In Response to Data Adequacy Review
of the
Application for Certification
for the
**GWF Energy LLC Tracy
Combined Cycle Power Plant
(GWF Tracy)**

(08-AFC-7)

Submitted to the
California Energy Commission

Submitted by
GWF Energy LLC

FIGURE TSE-1A
GWFF TRACY REVISED
ONE-LINE DRAWINGS
 GWFF TRACY COMBINED CYCLE
 POWER PLANT PROJECT
 SAN JOAQUIN COUNTY, CA

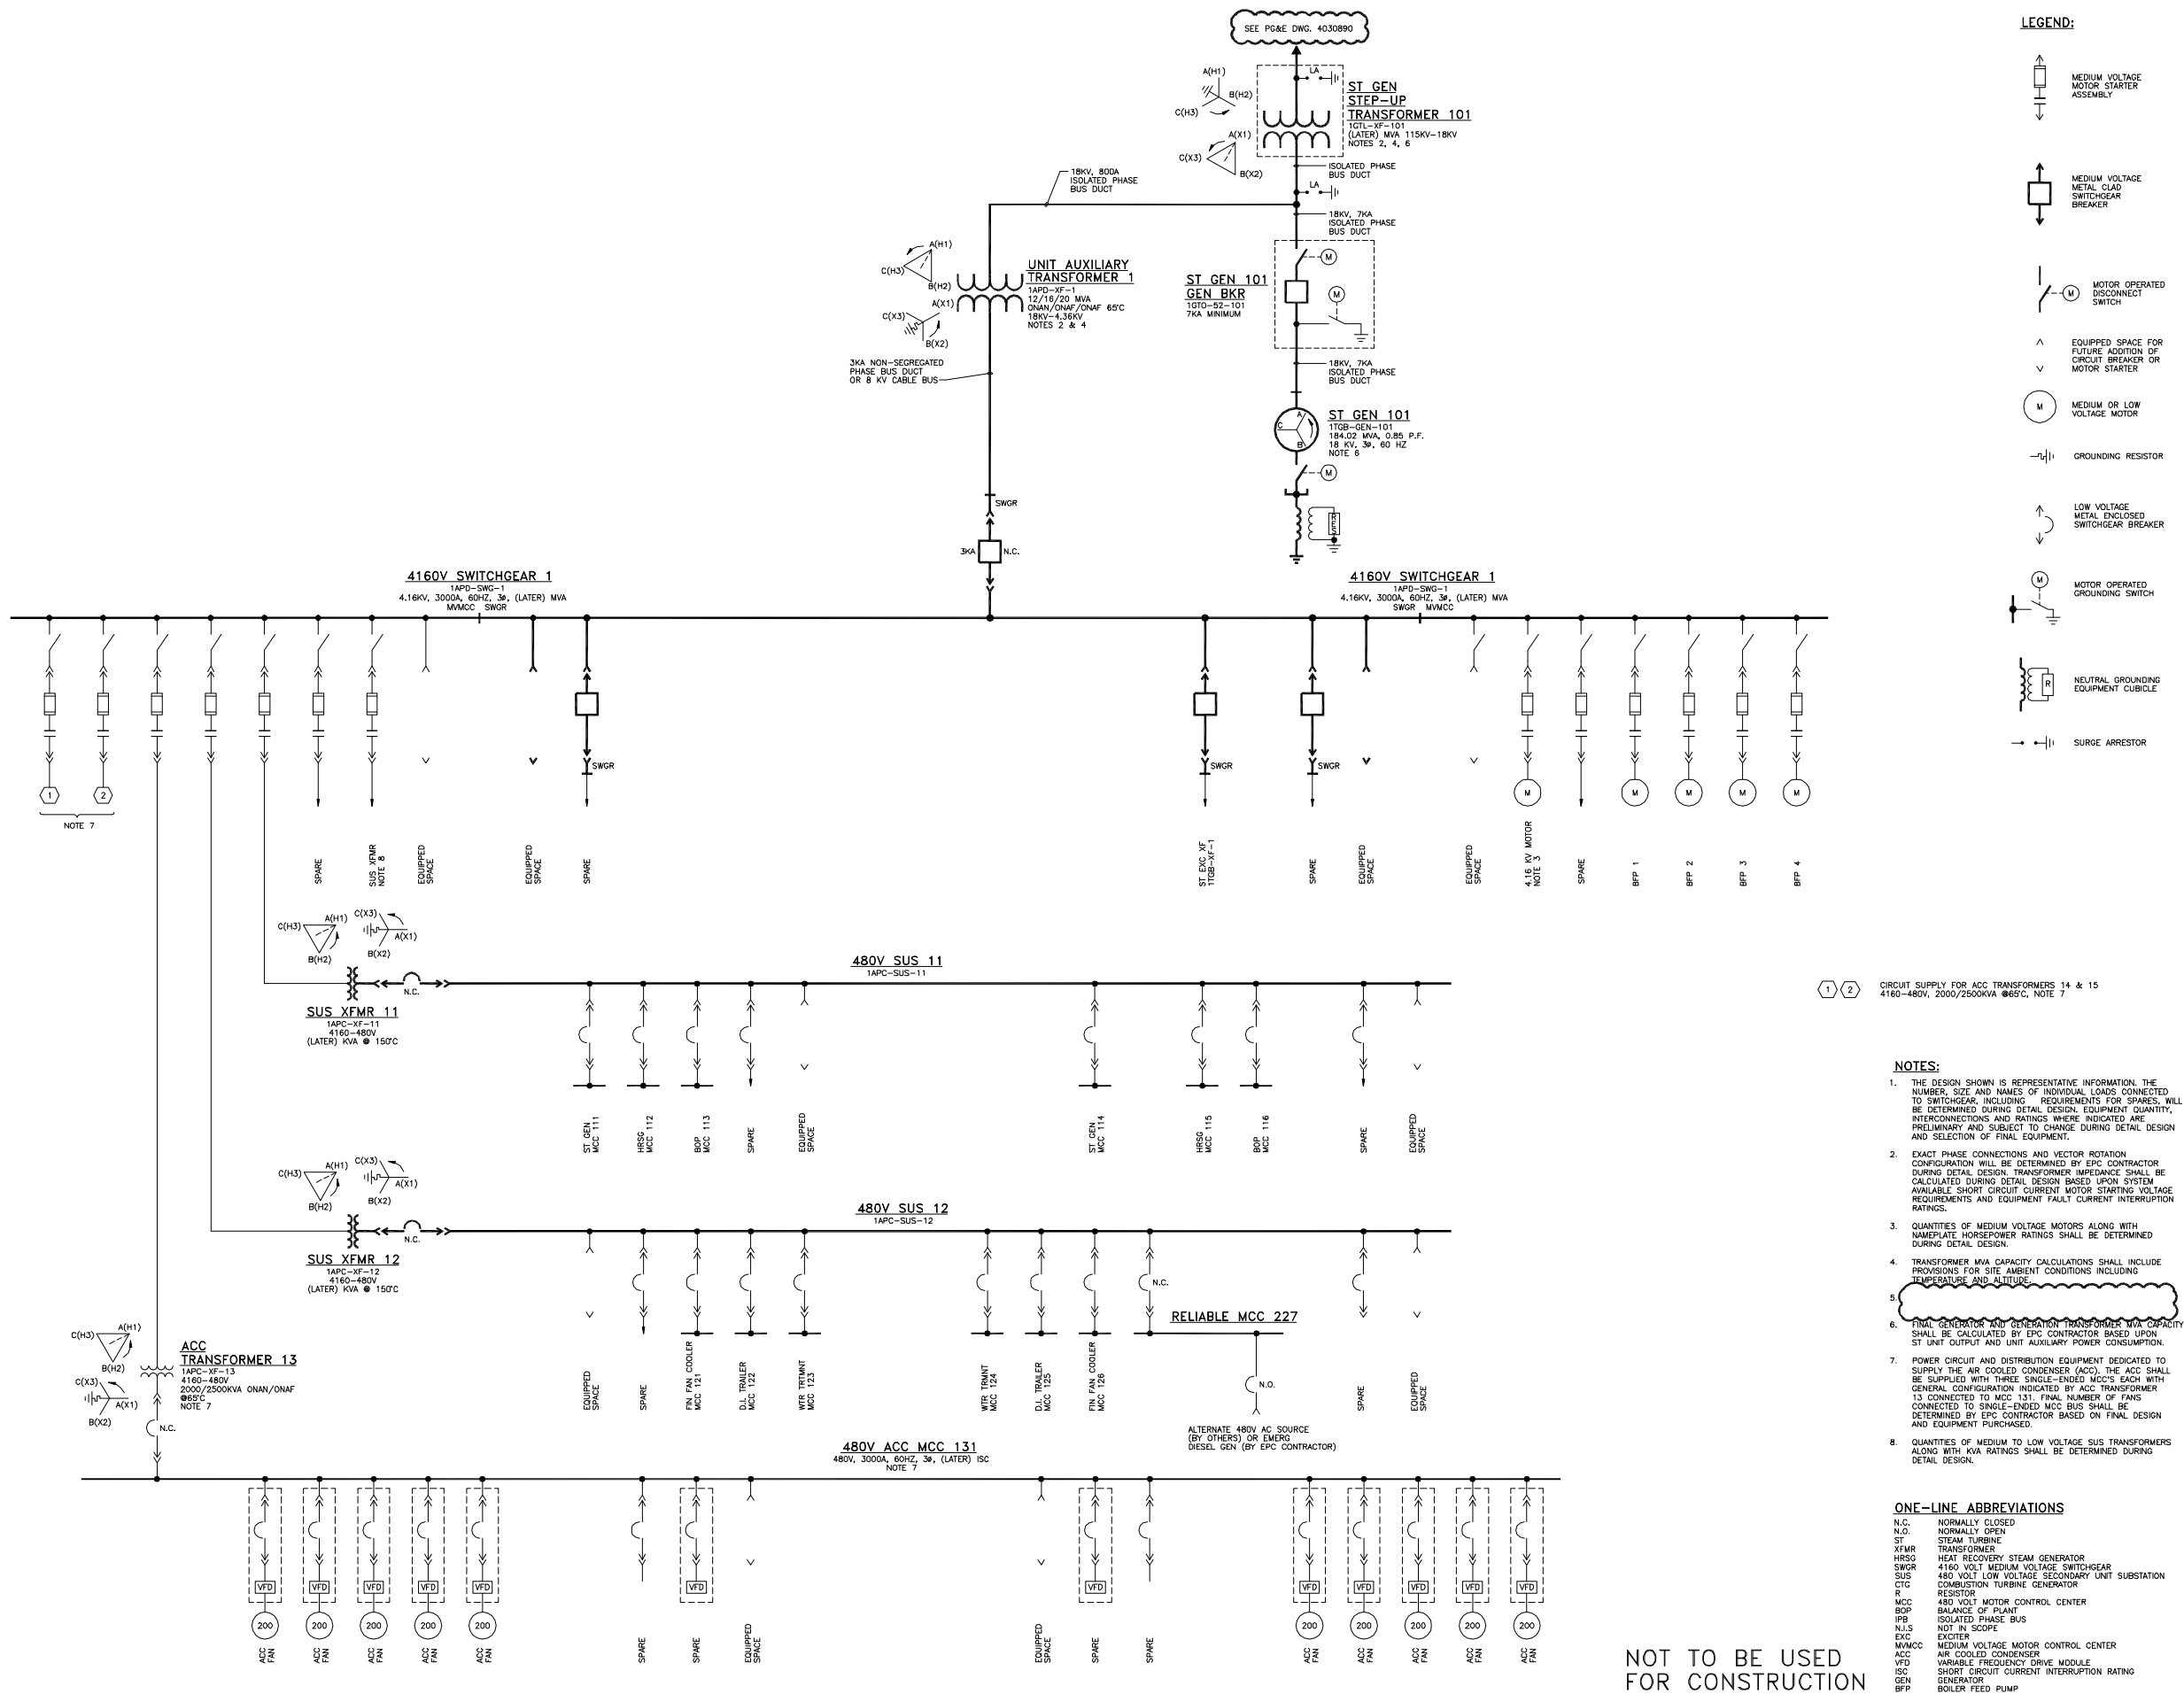
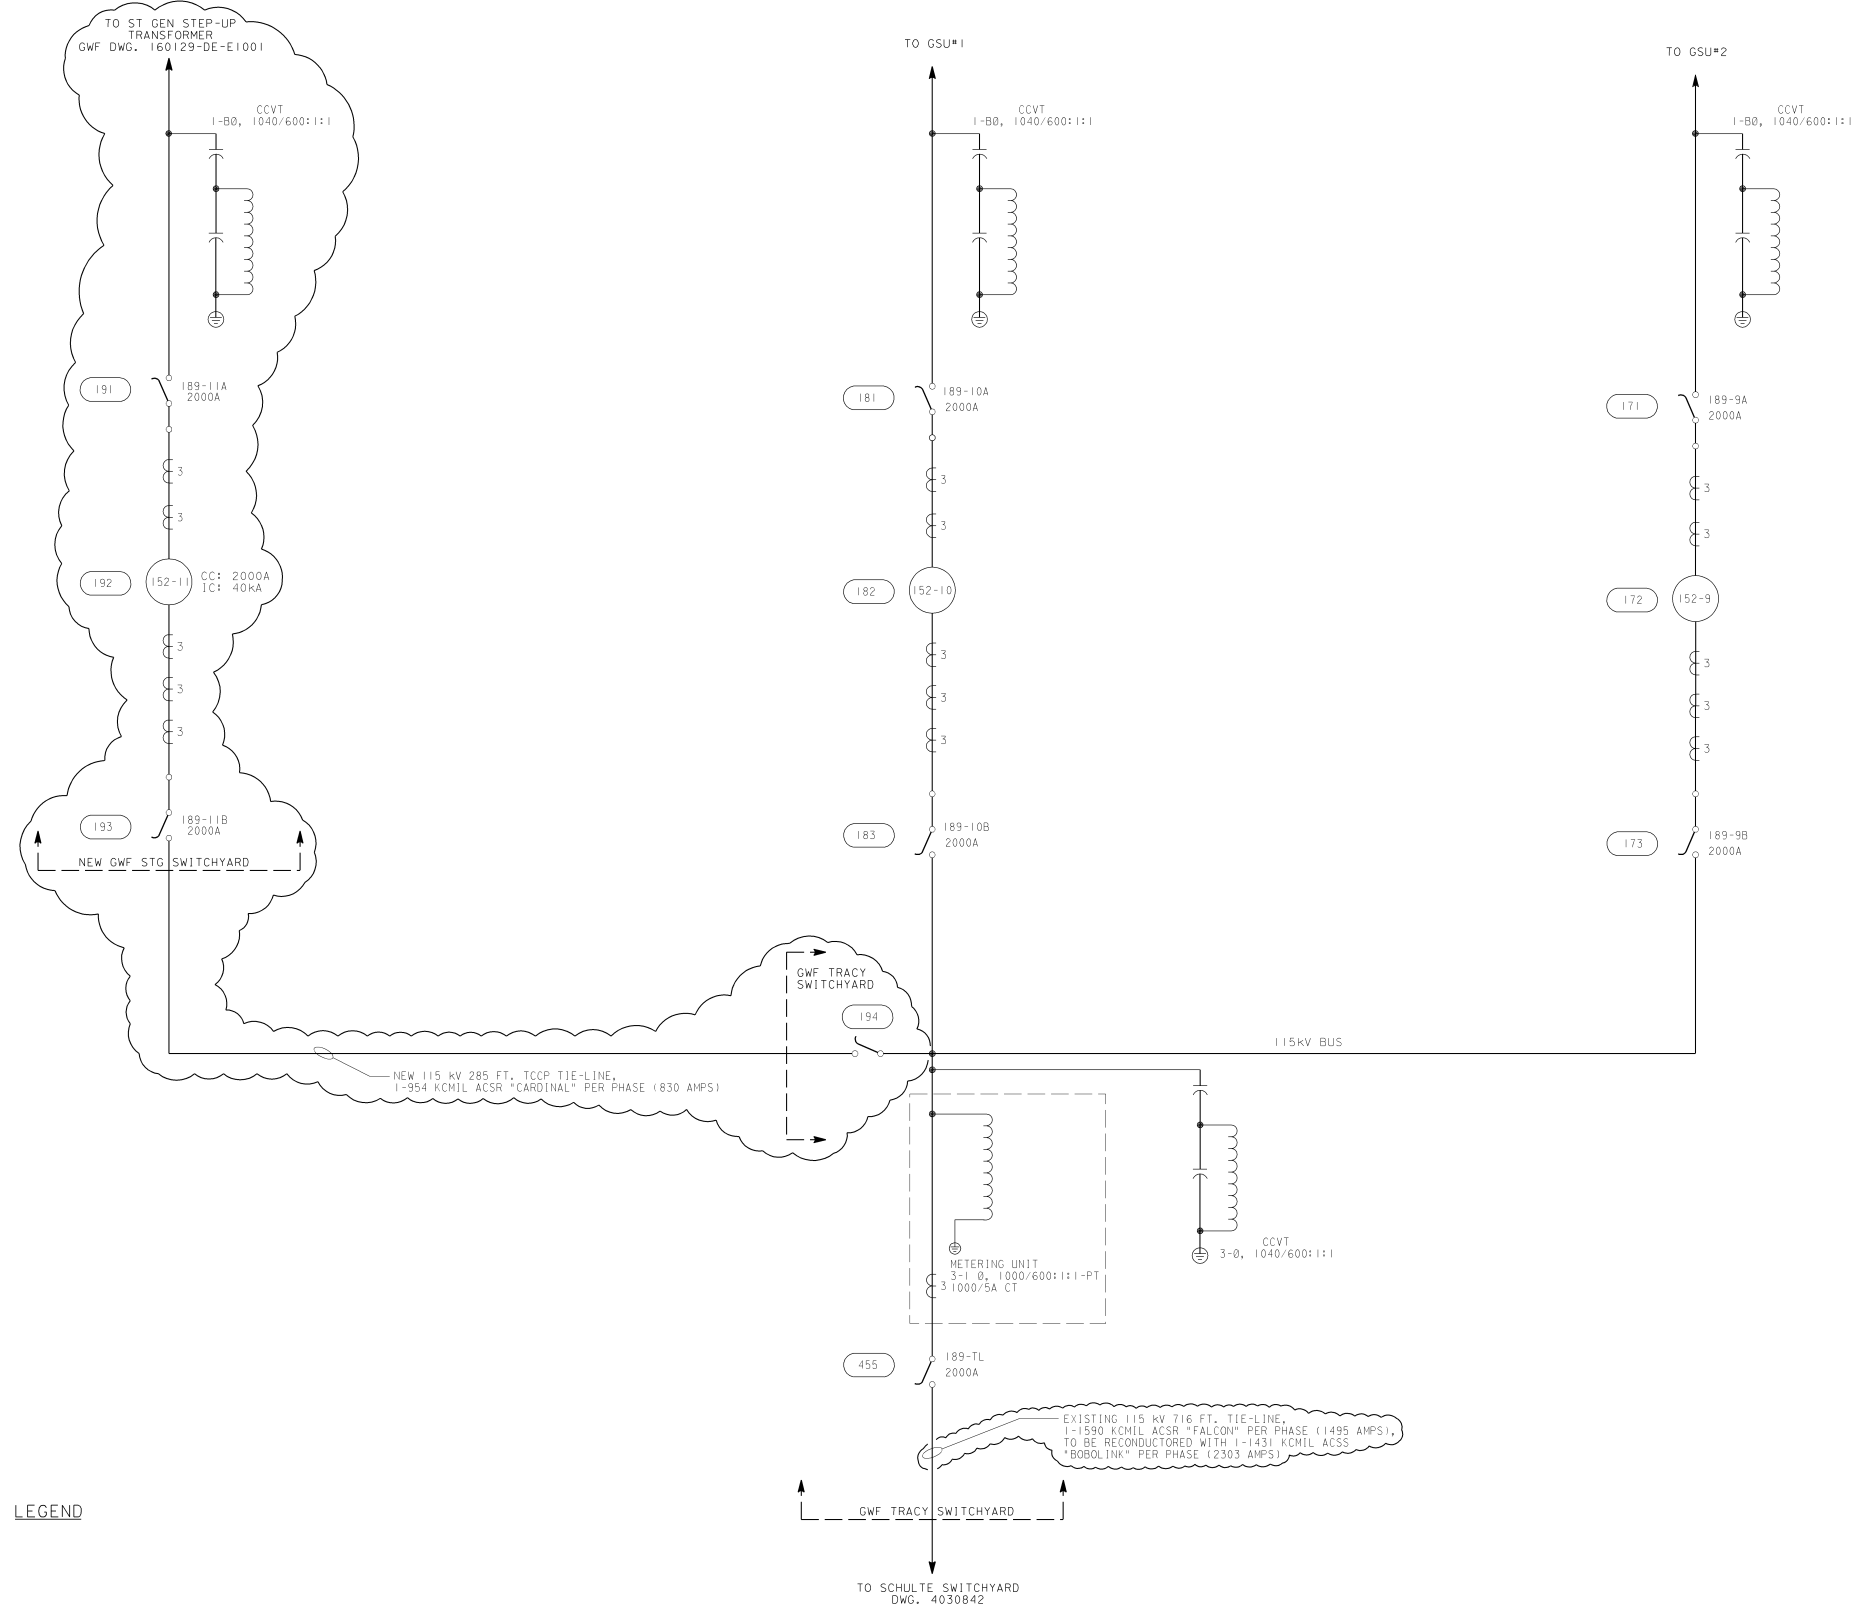
a. Please resubmit Figure 2.1-4 for a complete electrical one-line diagram of the proposed GWF Tracy Combined Cycle Power Plant (GWF Tracy) project showing all equipment and outlet lines including the generator step-up transformer (GSU), 115 KV SF6 breaker and disconnect switches on the high side, the 115 KV short overhead line from the GSU high side breaker to the existing GWF Tracy 115 kV switchyard with their respective sizes and/or types for the equipment, overhead conductor and ratings.

Response – Revised Figure 2.1-4 is attached as Figure TSE-1a and shows showing all equipment and outlet lines including the generator step-up transformer (GSU), 115 KV SF6 breaker and disconnect switches on the high side, the 115 KV short overhead line from the GSU high side breaker to the existing GWF Tracy 115 kV switchyard with their respective sizes and/or types for the equipment, overhead conductor and ratings.

FIGURE TSE-1C
GWF TRACY REVISED
ONE-LINE DRAWINGS
 GWF TRACY COMBINED CYCLE
 POWER PLANT PROJECT
 SAN JOAQUIN COUNTY, CA

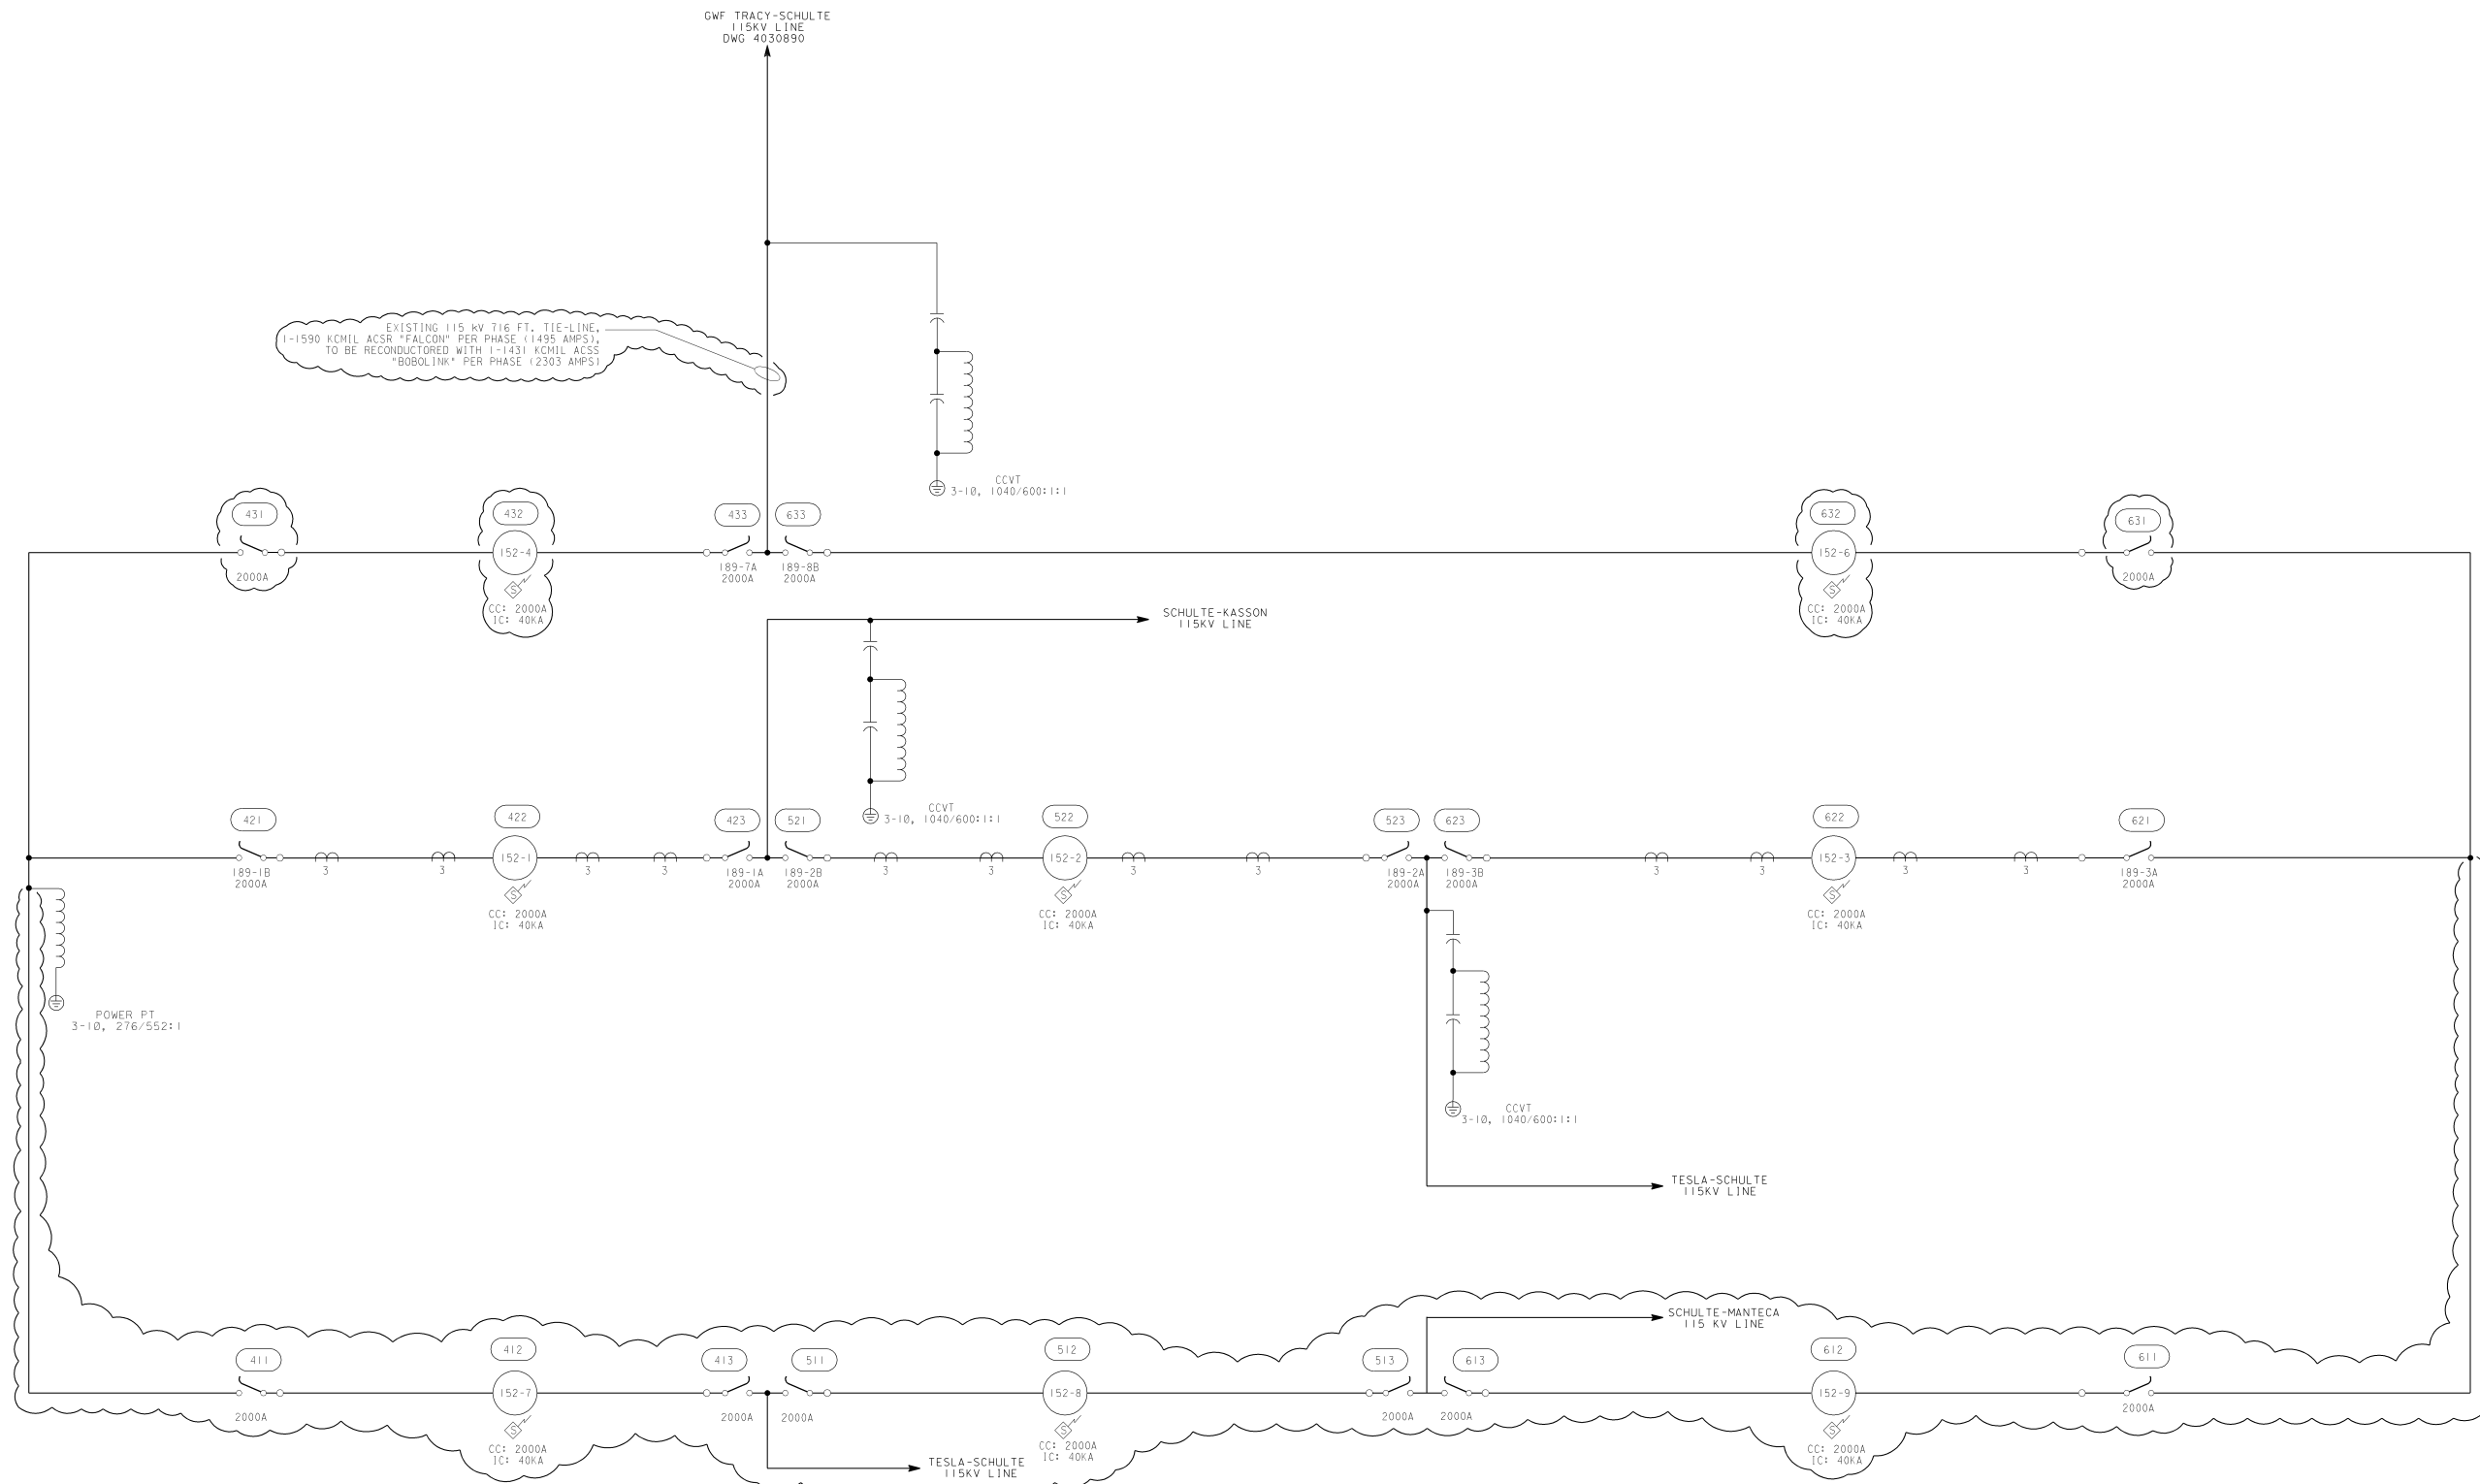
c. Please provide a one-line electrical diagram showing the pre and post-project existing PG&E 115 kV Schulte switching station showing the existing 115 kV generator overhead tie line with changes if any, with the configurations for 115 kV buses, breakers and disconnect switches and their respective ratings including all transmission outlet lines with the changes.

Response – Attached is a one-line electrical diagrams, Figure TSE-1c, showing the pre and post-project existing PG&E 115 kV Schulte switching station showing the existing 115 kV generator overhead tie line with changes if any, with the configurations for 115 kV buses, breakers and disconnect switches and their respective ratings including all transmission outlet lines with the changes.

EXISTING 115 KV 716 FT. TIE-LINE.
 1-1590 KCMIL ACSR "FALCON" PER PHASE (1495 AMP/PH).
 TO BE RECONDUCTED WITH 1-1431 KCMIL ACSS
 "BOBOLINK" PER PHASE (2303 AMP/PH)
